Subject: Subject: **Castleton BRF 015-2 (10)** –Night Lighting Plan

We have reviewed the Night Lighting Plan, dated March 2, 2015, for the above mentioned project.

Transmittal #: 5
Date: 3/2/2015
Job: M117 VTRANS CASTLETON BRP 015-2(10)

*Re: Town of Castleton, VT Route 30
BRF 015 - 2(10)
Nighttime Operations & Lighting Plan - Bridges 93*

FILE NAME: z22b32r14.dgn
 PROJECT LEADER: S.E. BURBANK
 DESIGNED BY: E.A. FALLA
 TRAFFIC SIGNS & LINE STRIPING SHEET

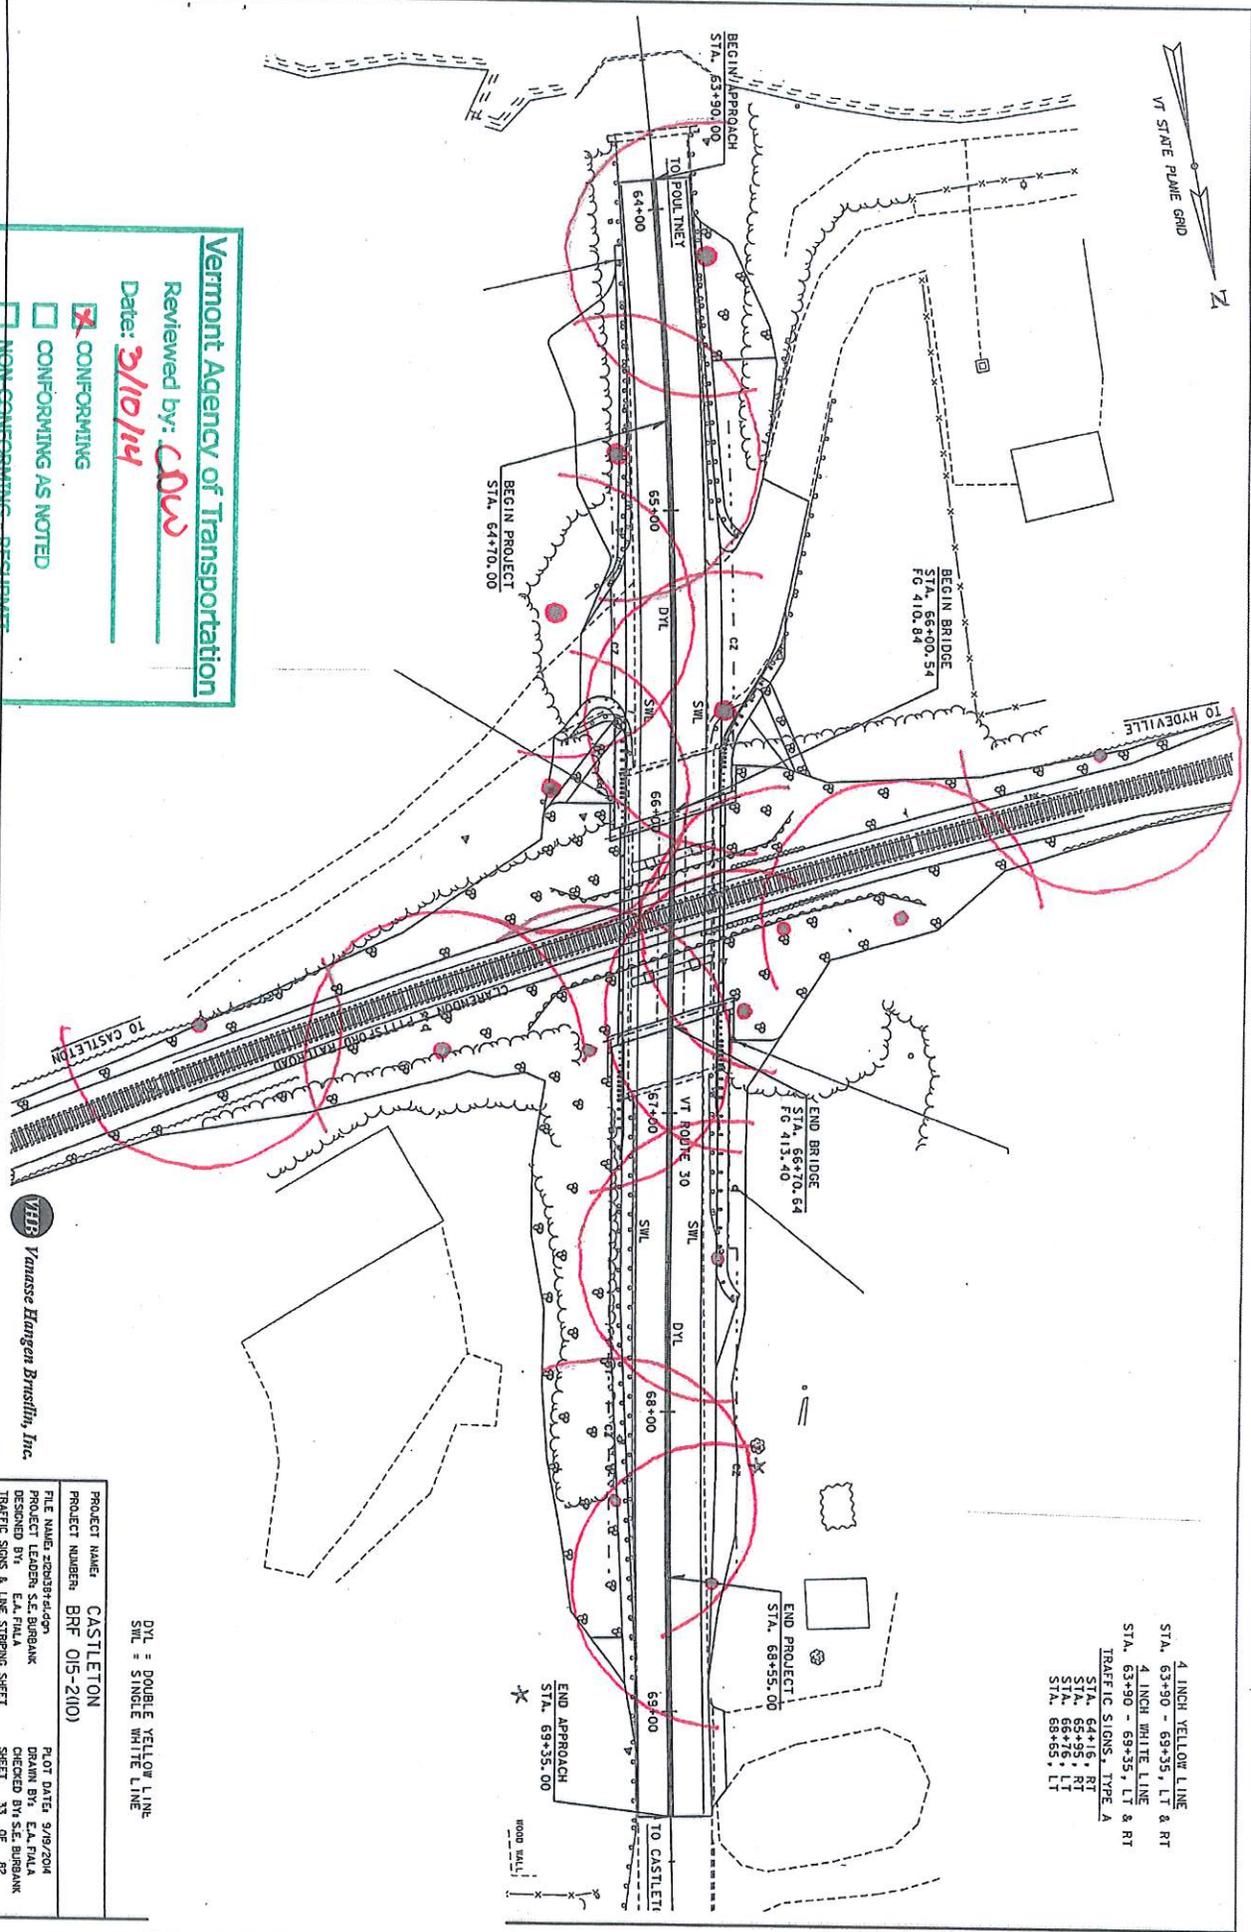
The Night Lighting Plan has been accepted but only for conformance to the contract.

- Additional units may be needed, this will have to be determined in the field and will need to be satisfactory to the engineer.
- You are also reminded of special provision #13 Nighttime Work restrictions. The contractor shall provide the engineer with a sound level meter.
